**Figure 7B-1. Signs in School Areas and at School Crossings** (Sheet 1 of 2)

# Summary of Comments on CAMUTCD 2026 7B Fig.pdf

# Summary of Comments on Part 7B Figure CA MUTCD 2026

**Figure 7B-2. Example of Signing for a School Zone with a School Speed Limit and a School Crossing**

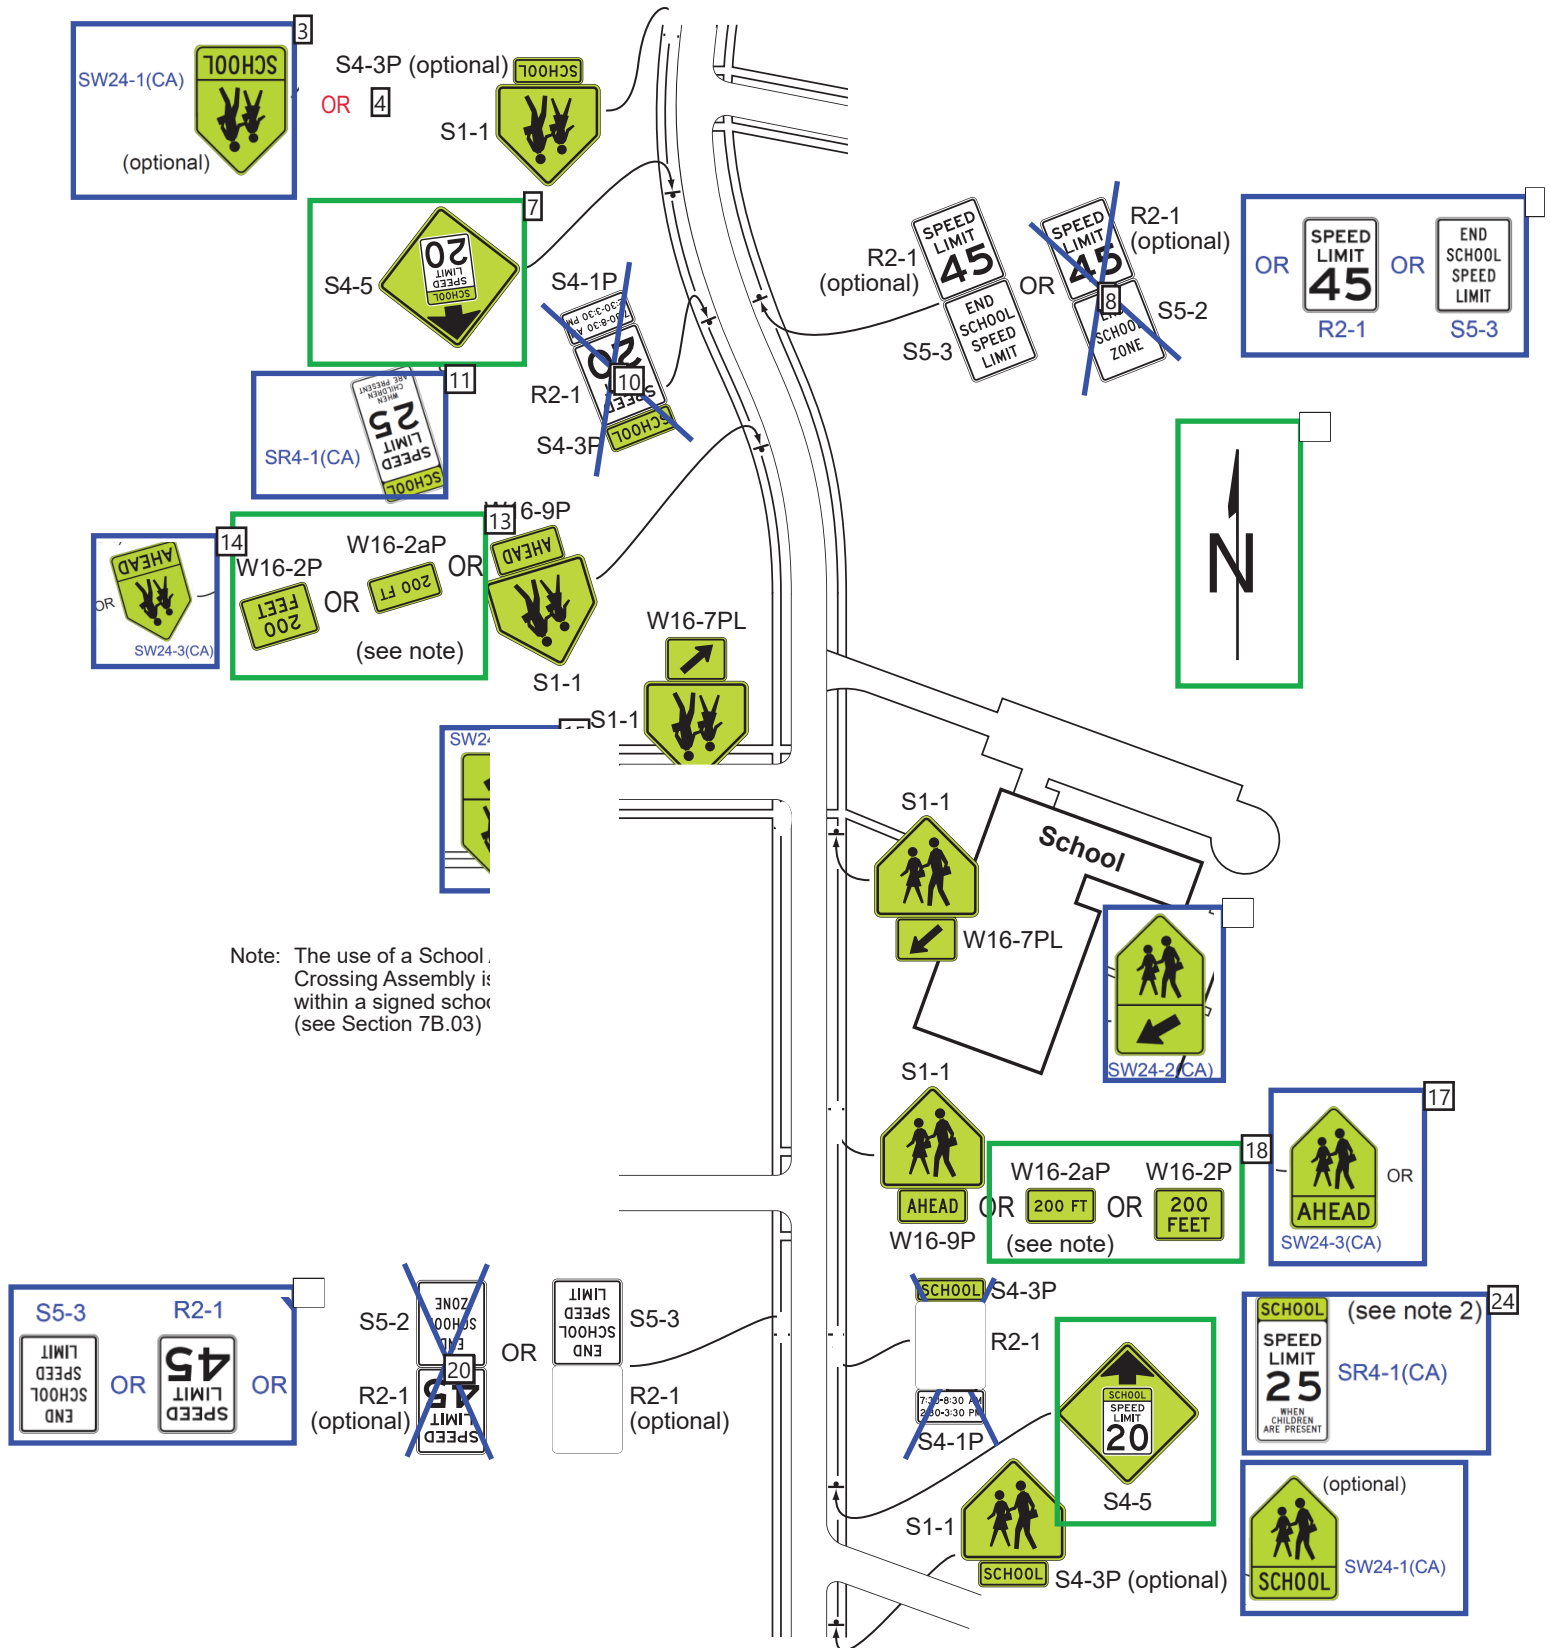
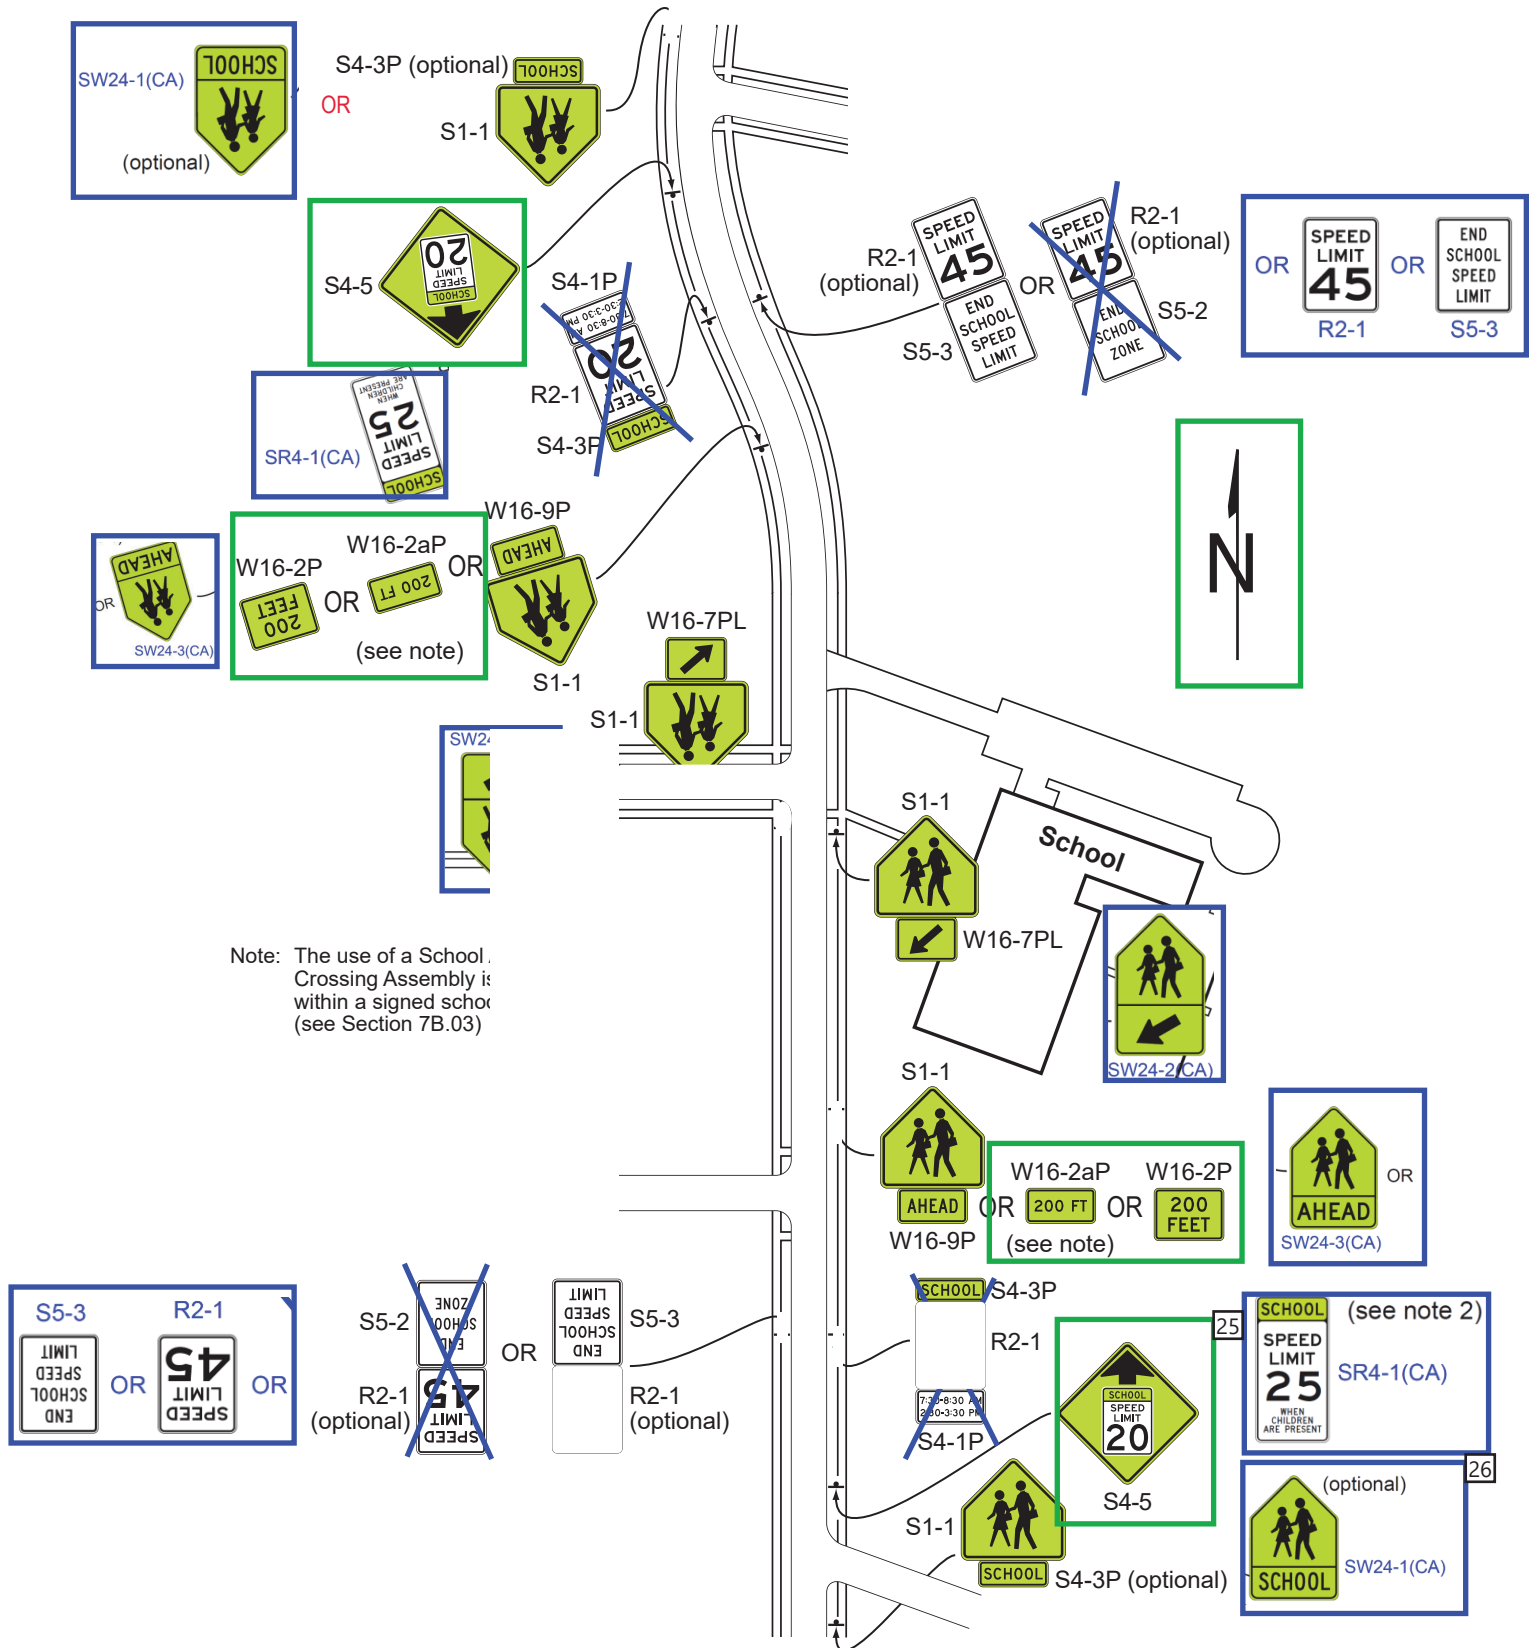
Number: 1	Author: s116730	Subject: Highlight	Date: 7/25/2024 9:48:20 AM
NMUTCD 2023 added sign codes for all signs, which were missing in NMUTCD 2009 figures				
	Number: 2	Author: s116730	Subject: Highlight	Date: 7/25/2024 9:48:24 AM
NMUTCD 2023 changed NMUTCD 2009 Figure 7B-5 to 7B-2 and added sign codes for the signs shown in the figure.				
	Number: 3	Author: s116730	Subject: Rectangle	Date: 7/10/2024 9:45:30 AM
Incorporated from CA MUTCD 2014R8 Figure 7B-5				
	Number: 4	Author: s116730	Subject: Text Box	Date: 7/10/2024 9:43:42 AM
OR				
	Number: 5	Author: s116730	Subject: Line	Date: 7/10/2024 9:37:58 AM
	Number: 6	Author: s116730	Subject: Rectangle	Date: 7/10/2024 9:55:06 AM
Incorporated from CA MUTCD 2014R8 Figure 7B-5				
	Number: 7	Author: s116730	Subject: Rectangle	Date: 7/14/2024 8:38:40 AM
NMUTCD 2023 added new sign				
	Number: 8	Author: s116730	Subject: Line	Date: 7/10/2024 9:37:47 AM
	Number: 9	Author: s116730	Subject: Line	Date: 7/10/2024 9:38:20 AM

Number: 10	Author: s116730	Subject: Line	Date: 7/10/2024 9:38:20 AM
	Number: 11	Author: s116730	Subject: Rectangle	Date: 7/10/2024 9:55:55 AM
Incorporated from CA MUTCD 2014R8 Figure 7B-5				
	Number: 12	Author: s116730	Subject: Rectangle	Date: 7/14/2024 8:40:44 AM
NMUTCD 2023 added new cardinal direction "N" arrow				
	Number: 13	Author: s116730	Subject: Rectangle	Date: 7/13/2024 10:10:07 AM
NMUTCD 2023 added new plaques				
	Number: 14	Author: s116730	Subject: Rectangle	Date: 7/10/2024 2:53:25 PM
Incorporated from CA MUTCD 2014R8 Figure 7B-5				
	Number: 15	Author: s116730	Subject: Rectangle	Date: 7/10/2024 2:34:53 PM
Incorporated from CA MUTCD 2014R8 Figure 7B-5				
	Number: 16	Author: s116730	Subject: Rectangle	Date: 7/10/2024 2:35:20 PM
Incorporated from CA MUTCD 2014R8 Figure 7B-5				
	Number: 17	Author: s116730	Subject: Rectangle	Date: 7/10/2024 9:56:34 AM
Incorporated from CA MUTCD 2014R8 Figure 7B-5

Number: 18	Author: s116730	Subject: Rectangle	Date: 7/13/2024 10:10:21 AM
NMUTCD 2023 added new plaques				
	Number: 19	Author: s116730	Subject: Line	Date: 7/10/2024 9:51:04 AM
	Number: 20	Author: s116730	Subject: Line	Date: 7/10/2024 9:50:49 AM
	Number: 21	Author: s116730	Subject: Line	Date: 7/10/2024 9:40:05 AM
	Number: 22	Author: s116730	Subject: Line	Date: 7/10/2024 9:39:53 AM
	Number: 23	Author: s116730	Subject: Rectangle	Date: 7/10/2024 9:56:16 AM
Incorporated from CA MUTCD 2014R8 Figure 7B-5				
	Number: 24	Author: s116730	Subject: Rectangle	Date: 7/10/2024 9:57:20 AM

☐ Number: 25 Author: s116730 Subject: Rectangle Date: 7/13/2024 10:10:35 AM  
NMUTCD 2023 added new sign

☐ Number: 26 Author: s116730 Subject: Rectangle Date: 7/10/2024 9:56:45 AM  
Incorporated from CA MUTCD 2014R8 Figure 7B-5

Figure 7B-2(CA) Example of Signing for a School Zone with a School Speed Limit and a School Crossing

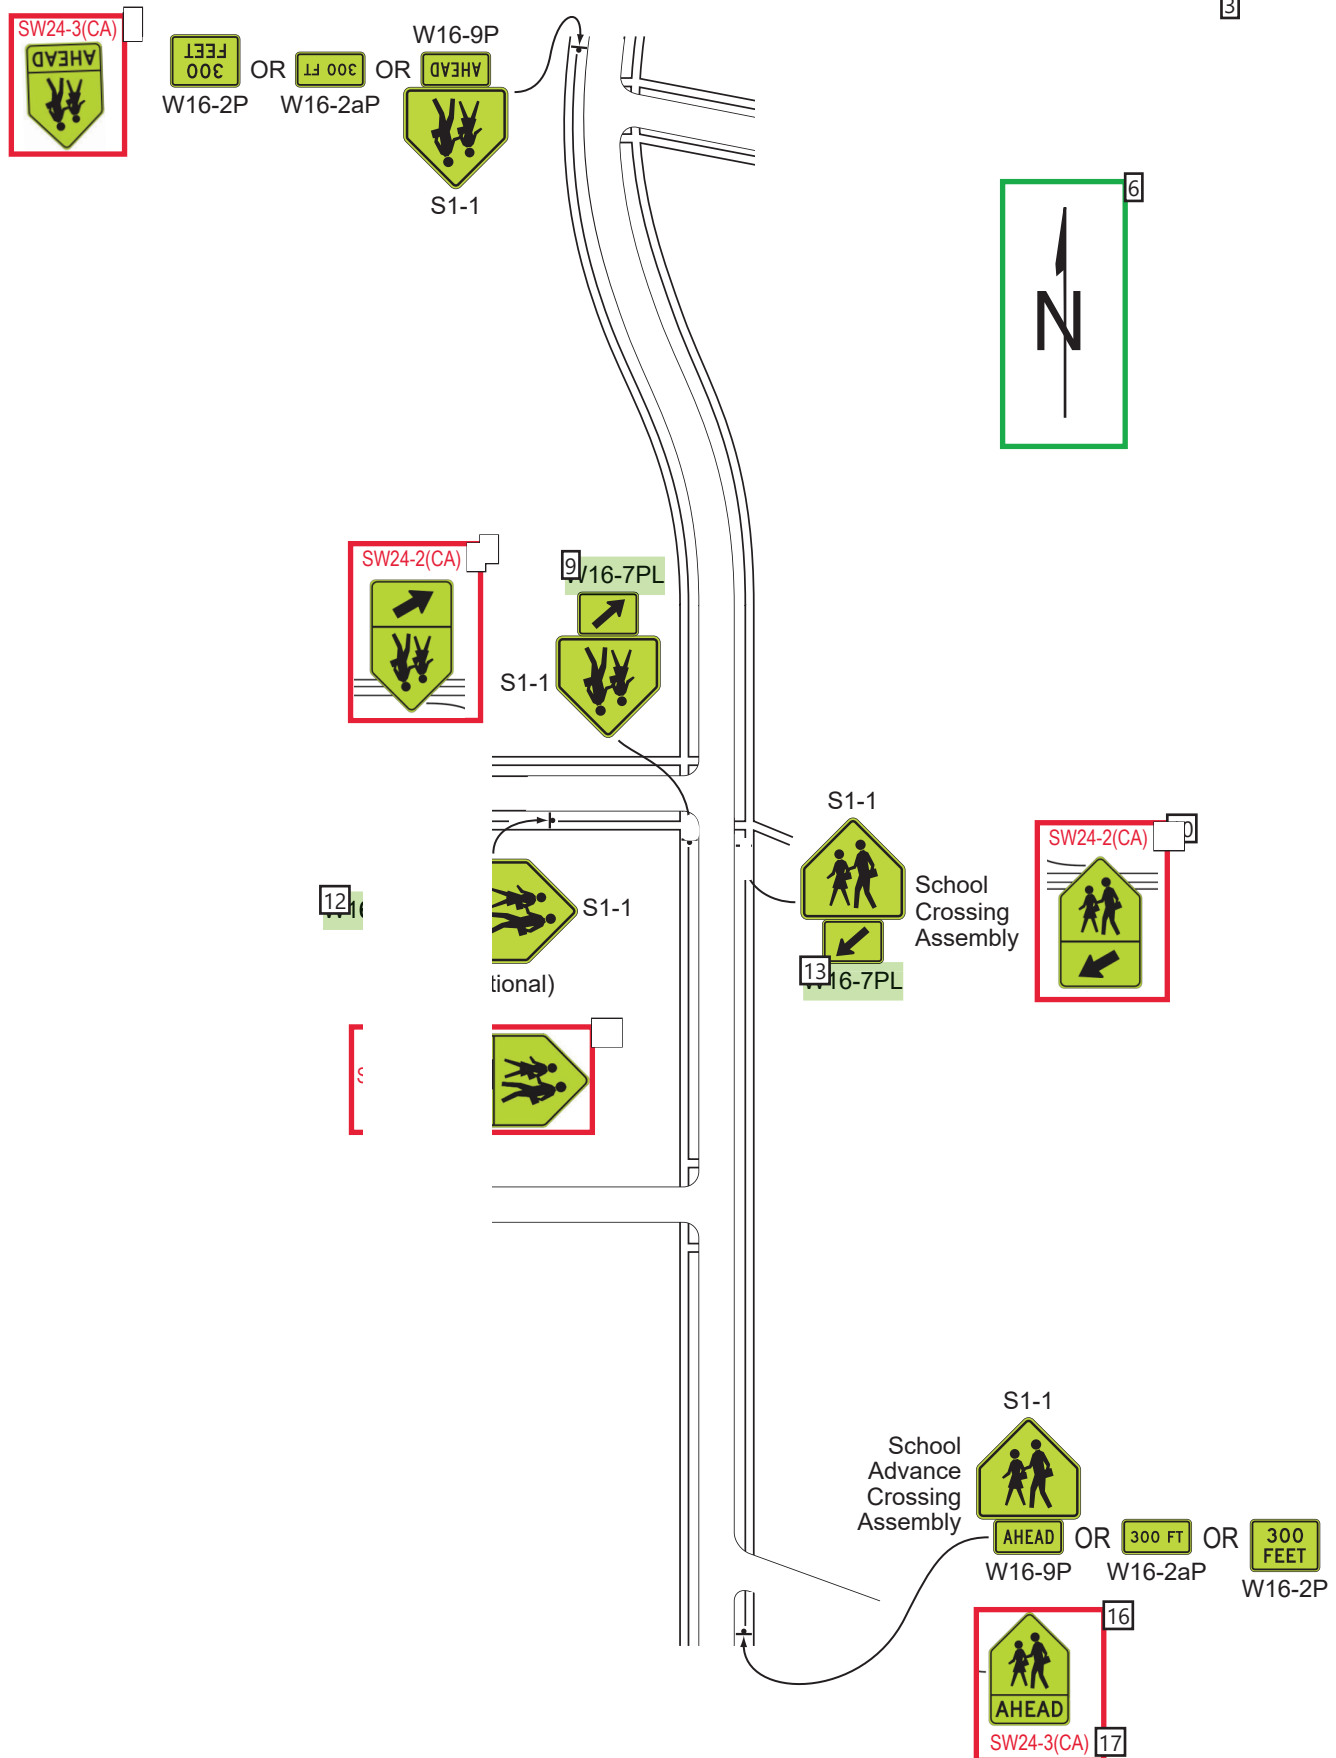
Number: 1	Author: s116730	Subject: Rectangle	Date: 7/10/2024 3:54:08 PM
	Number: 2	Author: s116730	Subject: Rectangle	Date: 7/10/2024 3:56:44 PM
	Add new note: 3. See Section 7B.02 for Assembly A(CA), Section 7B.03 for Assemblies B(CA), D(CA) and E(CA), and Section 7B.05 for Assembly C.			
	Number: 3	Author: s116730	Subject: Text Box	Date: 7/10/2024 3:39:15 PM
			7B-2(CA)	
	Number: 4	Author: s116730	Subject: Line	Date: 7/10/2024 3:52:15 PM
	NMUTCD 2023 changed NMUTCD 2009 Figure 7B-5 to 7B-2. This figure is renumbered as 7B-2(CA) and is included in CA MUTCD 2026			
	Number: 5	Author: s116730	Subject: Highlight	Date: 7/25/2024 9:49:13 AM
	NMUTCD 2023 changed NMUTCD 2009 Figure 7B-5 to 7B-2. This figure is renumbered as 7B-2(CA) and is included in CA MUTCD 2026

**Figure B-3. Example of Signing for a School Crossing Outside of a School Zone**

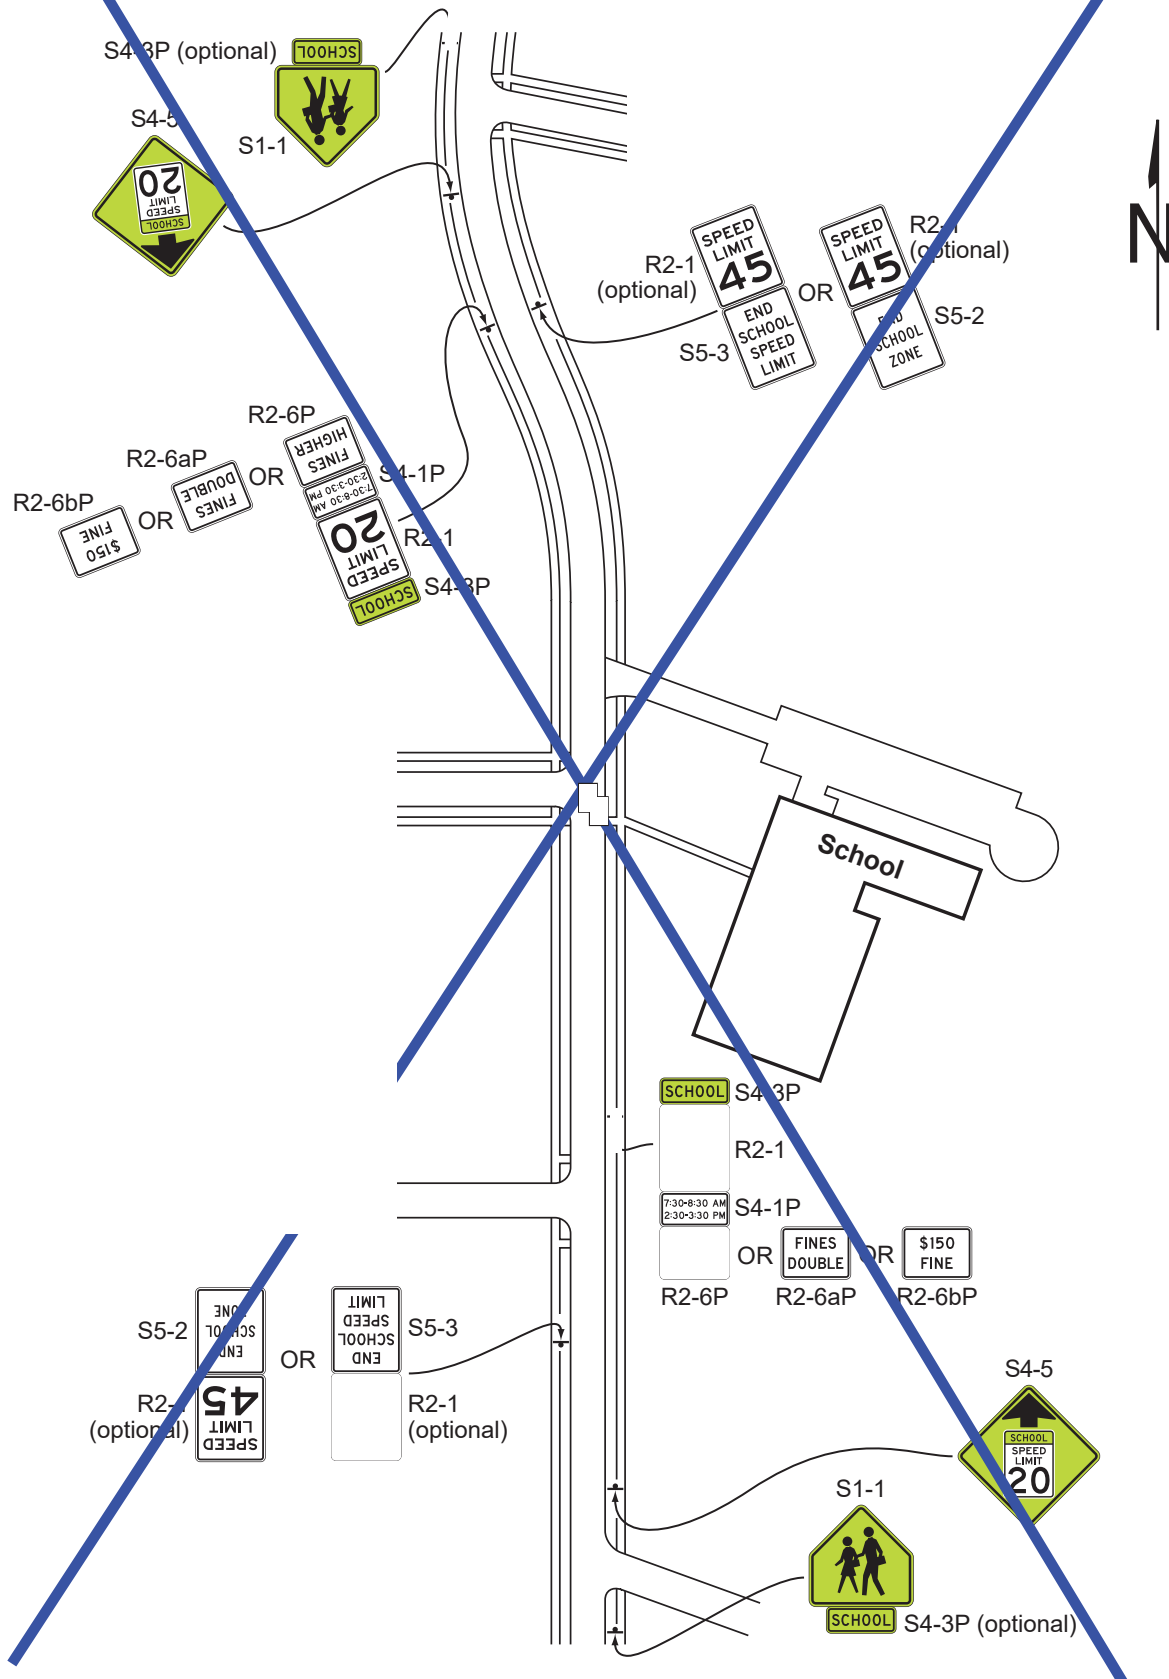
Number: 1 Author: s116730 Subject: Highlight Date: 7/25/2024 9:49:29 AM  
Options for CA signs that are combined with plaques (for all signs shown on this sheet) will be added

Number: 2 Author: s116730 Subject: Highlight Date: 7/25/2024 9:49:32 AM  
NMUTCD 2023 changed NMUTCD 2009 Figure 7B-4 to 7B-3 and added sign codes for the signs shown in the figure.

Number: 4 Author: s116730 Subject: Rectangle Date: 7/10/2024 3:20:12 PM  
Add SW24-3(CA) Assembly D(CA) image

Number: 7 Author: s116730 Subject: Rectangle Date: 7/10/2024 3:21:59 PM  
Add SW24-2(CA) Assembly B(CA) image

Number: 9 Author: s116730 Subject: Highlight Date: 7/25/2024 9:49:59 AM  
NMUTCD 2023 changed the NMUTCD 2009 sign code "W16-7P" to "W16-7PL"

Number: 10 Author: s116730 Subject: Rectangle Date: 7/10/2024 3:21:47 PM  
Add SW24-2(CA) Assembly B(CA) image

Number: 12 Author: s116730 Subject: Highlight Date: 7/25/2024 9:50:05 AM  
NMUTCD 2023 changed the NMUTCD 2009 sign code "W16-6P" to "W16-6PR"

Number: 13 Author: s116730 Subject: Highlight Date: 7/25/2024 9:50:09 AM  
NMUTCD 2023 changed the NMUTCD 2009 sign code "W16-7P" to "W16-7PL"

Number: 14 Author: s116730 Subject: Rectangle Date: 7/10/2024 3:23:06 PM  
Add SW24-1(CA) Assembly A(CA) image

Number: 16 Author: s116730 Subject: Rectangle Date: 7/10/2024 3:22:25 PM  
Add SW24-3(CA) Assembly D(CA) image
